**Re: 25 Forge Parkway
Site Plan Modification**

BETA Group, Inc. is pleased to provide our engineering peer review services for the proposed site plan modification entitled "**Site Development Plans for 25 Forge Parkway**" located at 25 Forge Parkway in Franklin, Massachusetts. This letter is provided to outline findings, comments, and recommendations.

DATE: January 30, 2024
TO: Franklin Planning Board
FROM: Department of Planning and Community Development
RE: 25 Forge Parkway
Site Plan Modification

A&M Project #: 2712-02
Re: 25 Forge Parkway
Industrial/Warehouse
Response to Review
Comments

DRAWING TITLE: FIRE TRUCK TURNING FIGURE	SHEET No. 2
--	-----------------------

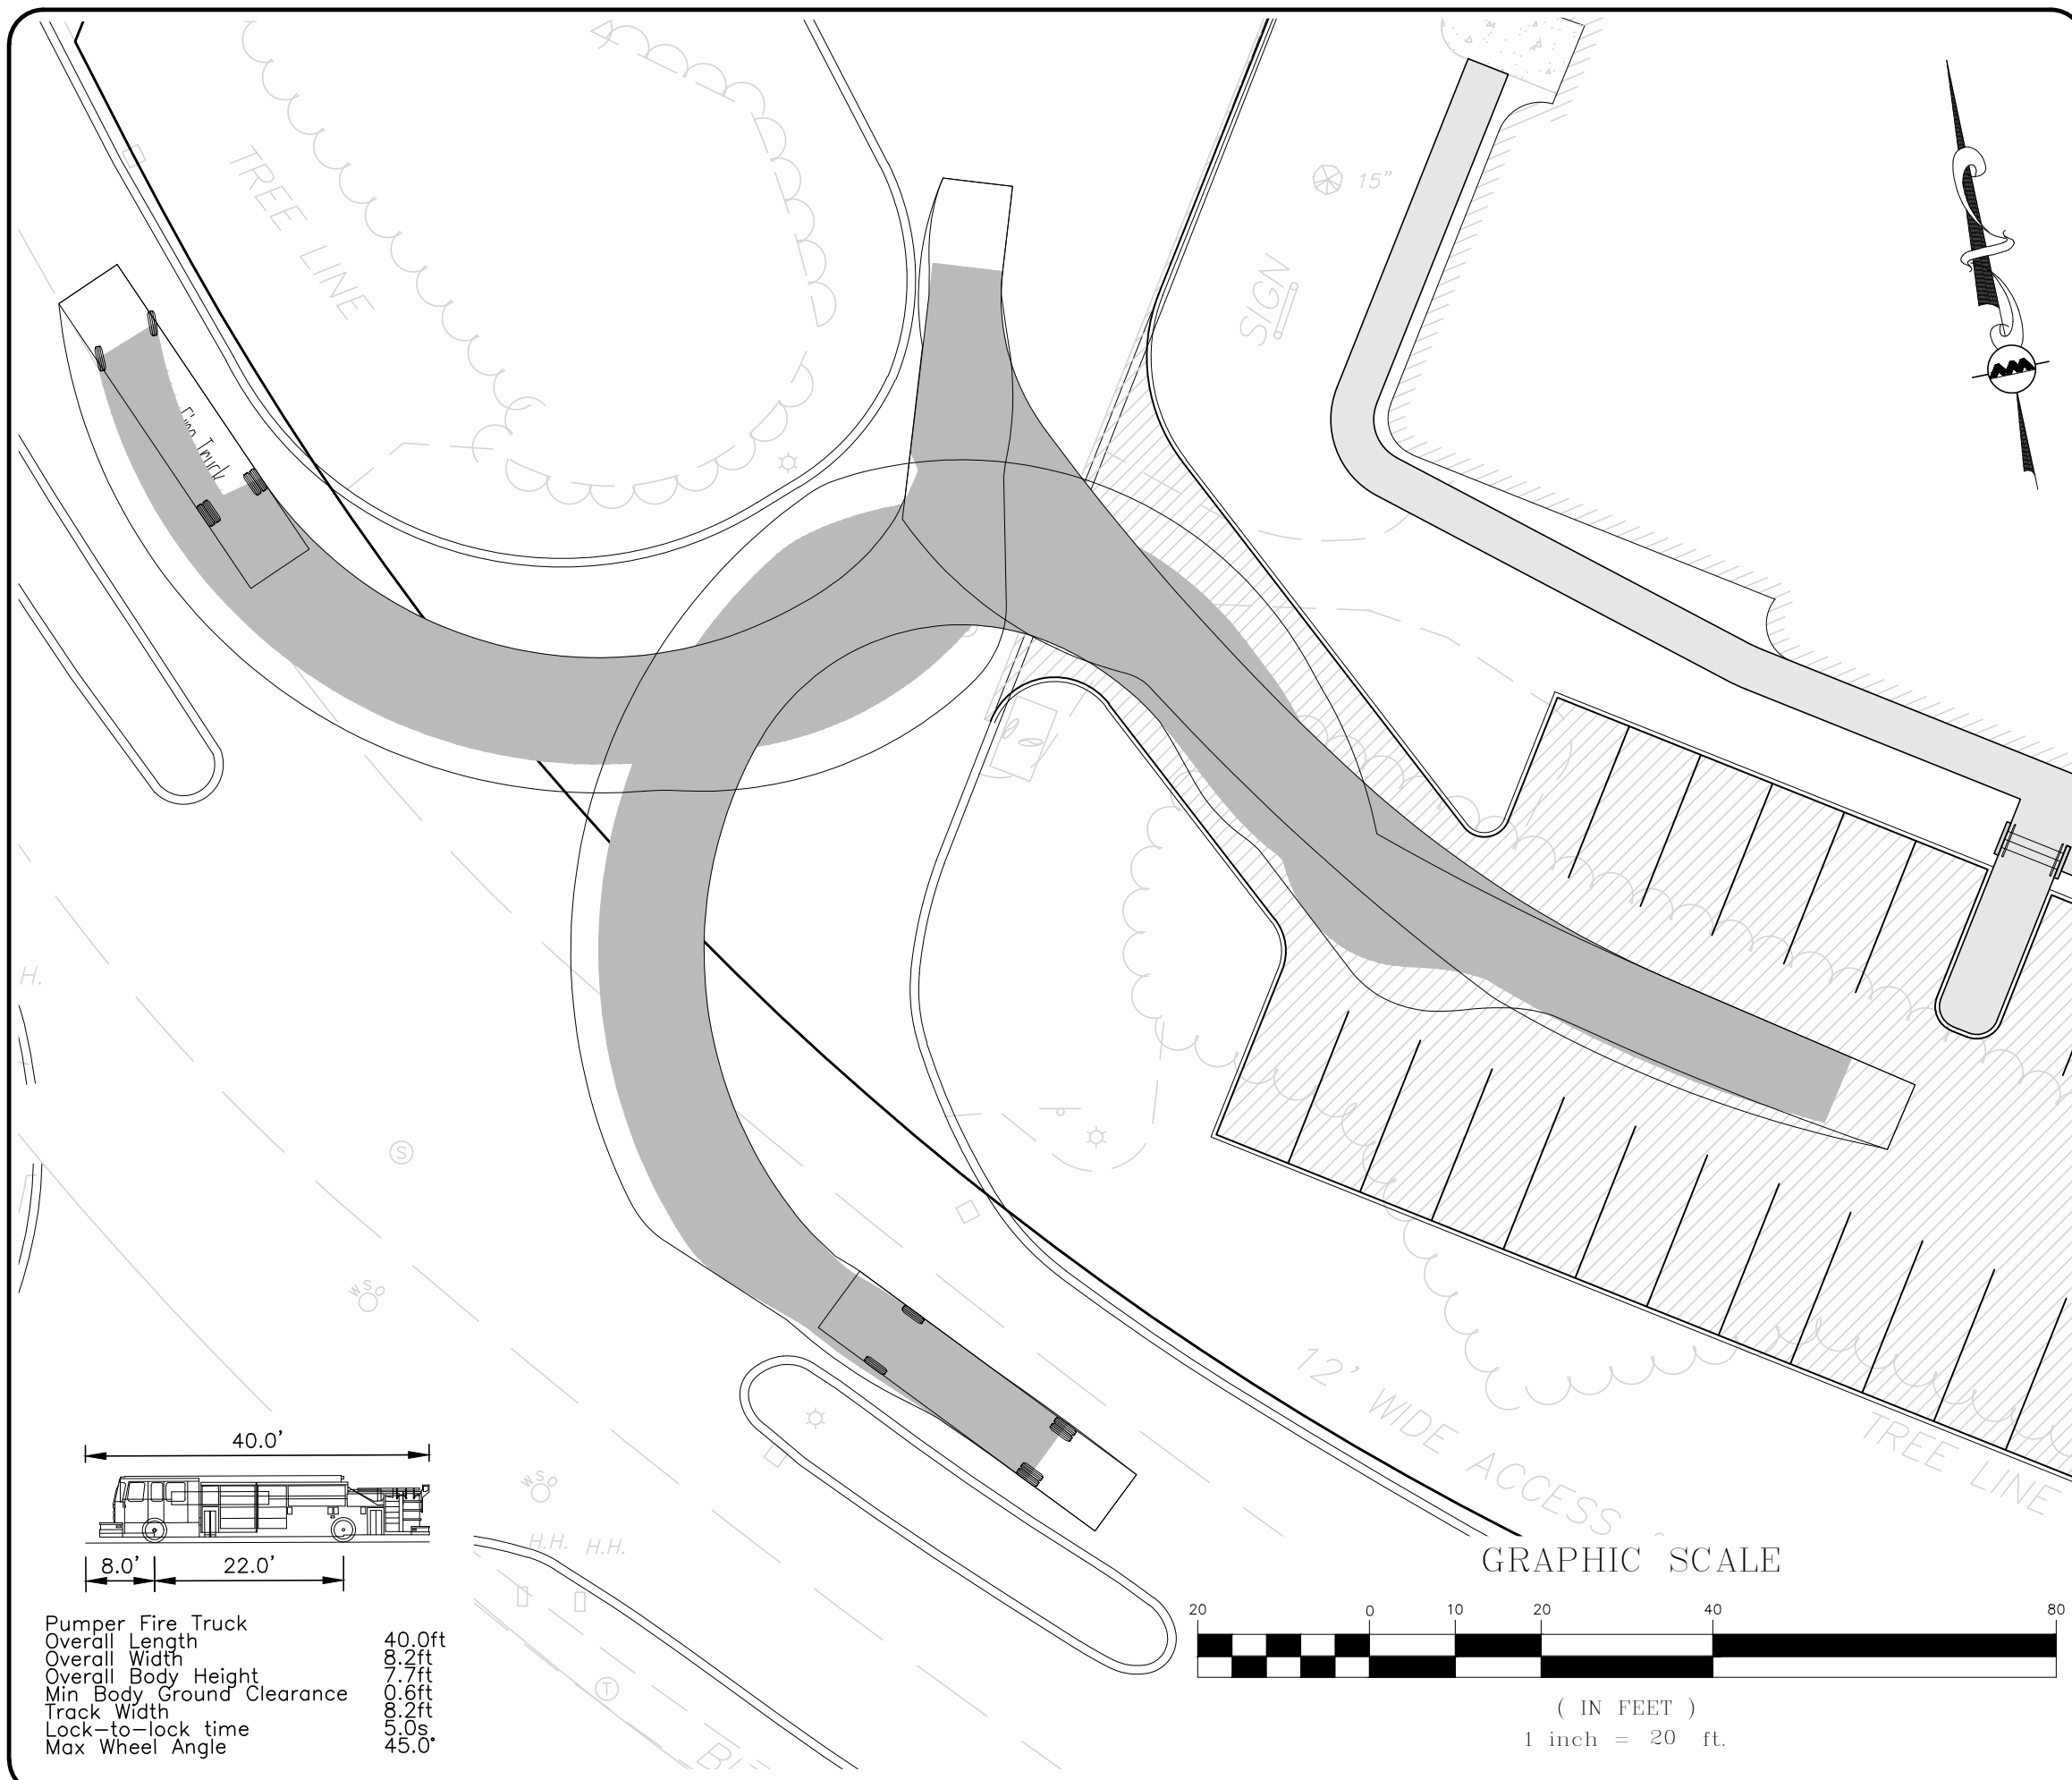
Thank you for the opportunity to review the above mentioned plan. The proposed parking lot on the south side of the building would provide additional access to the building for the Fire Department. We would just note that it may be tight to make a sharp right hand turn into the proposed parking lot coming off the main entrance given the size of our fire apparatus. A truck turning analysis at that juncture may be beneficial and clarify the issue.

A&M Response: Please see the attached Fire Truck Turning Figure, which shows a fire apparatus can enter and exit the proposed parking lot without conflict.
